# CREWSAVER SERVICING AND MAINTENANCE BULLETIN No. 29

**SUBJECT:** Harvester

## Harvester Attachment Method Conversion Procedure

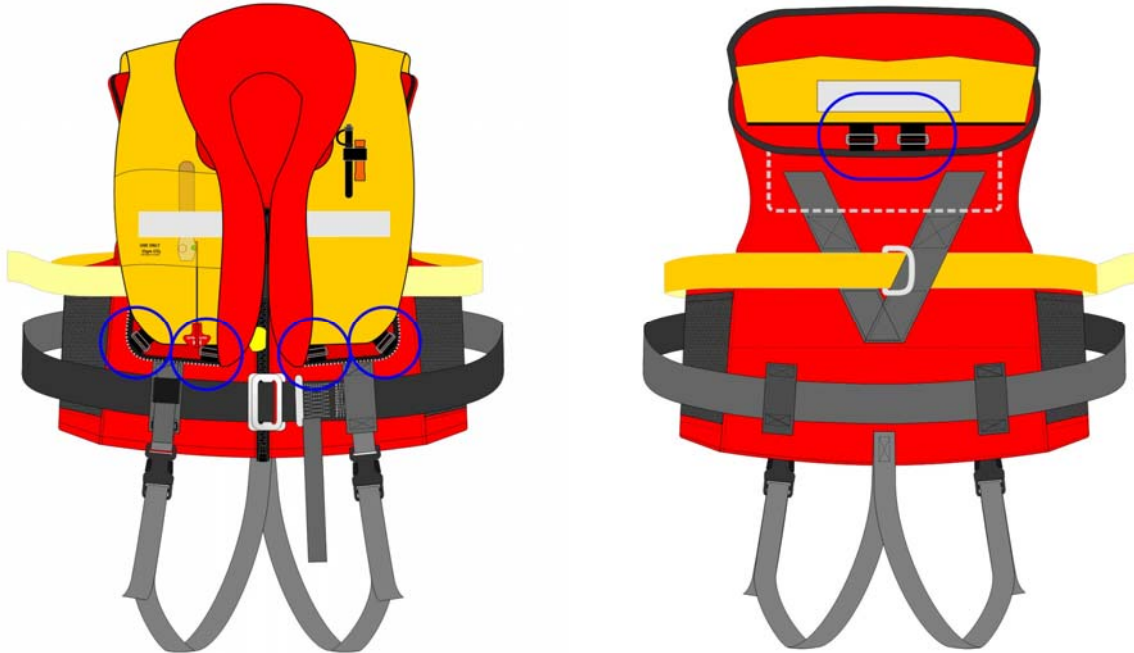
The square links that attach the inflation chamber to the cover require removal these can be located at the bottom of the front cover and at the centre back inside indicated on the above drawings by the Blue circles. There are 6 square links attached to the cover and 6 square links attached to the inflation chamber.

- 1 Cut all the Harvester Square Links from the cover and the inflation chamber using sharp heavy duty cutters, leaving the webbing loops intact. The square links are quite strong so they must be snipped on both sides of the webbing loop and threaded out of the loops. These are then discarded. See photos below:

2 Thread one cord through the inflation chamber and cover webbing loops where the square links were attached. Thread the cord back through the opposite loop creating a doubled loop, which is then pulled tight so the webbing loops are as close as possible.

3 A reef knot is then tied in the cord.

4 The 2 cord ends are then brought together and loop tied to themselves.

- 5 The ends of the cord should be even. The knots should be tied so that the knots face each other as shown in the photo below. The Cord ends are then tucked up behind the inflator.
